U.S. NUCLEAR REGULATORY COMMISSION
OFFICE OF INSPECTION AND ENFORCEMENT

Report No. 50-317/80-10
50-318/80-09
Docket No. 50-317
50-318
License No. DPR-53 Priority -- Category C
DPR-69

Facility Name: Calvert Cliffs Nuclear Power Plant Units 1 and 2

Inspection Summary:

FIGURE IA-I

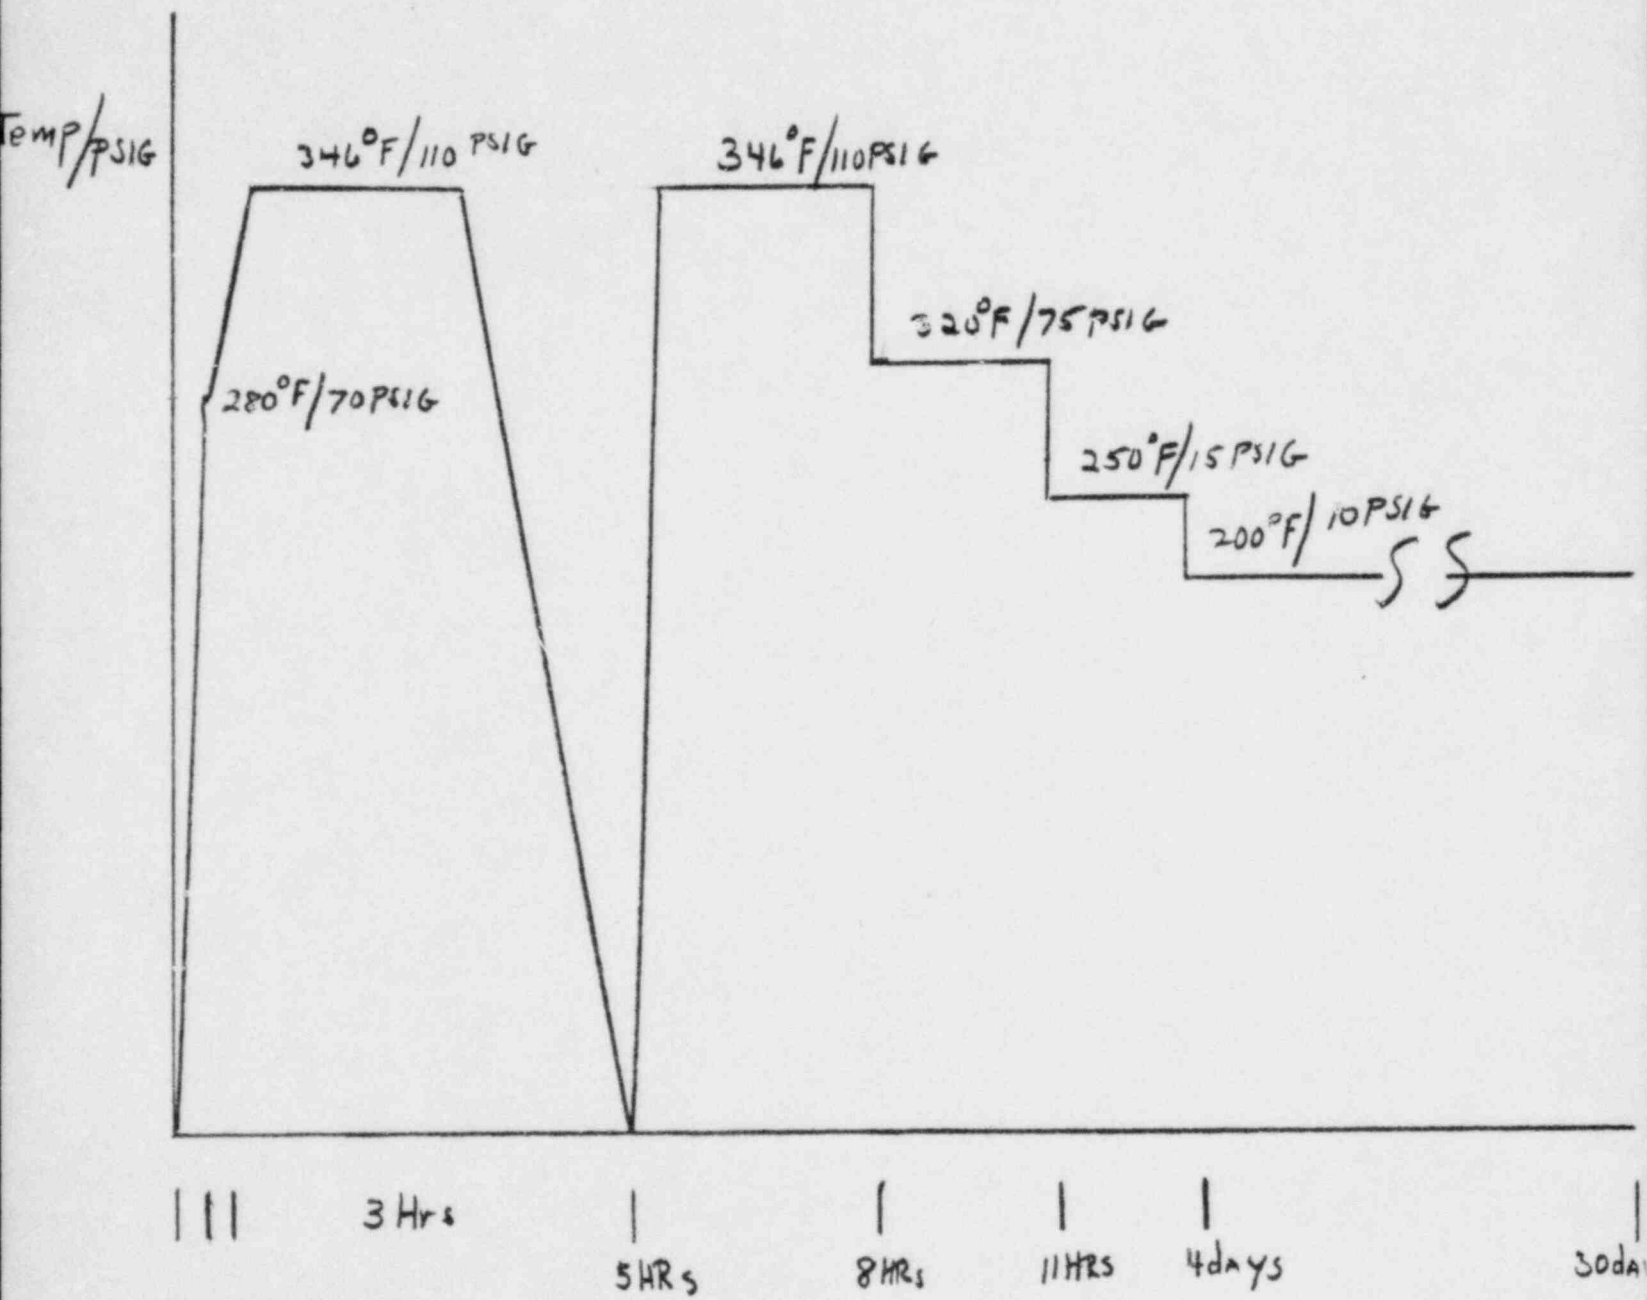
LOCA - The licensee used as a guide IEEE 323-1974 Figure 1A. The curve in Figure IA-1 represents the data points that the test conformed to. The times are approximate with no intent to reproduce the actual curve.
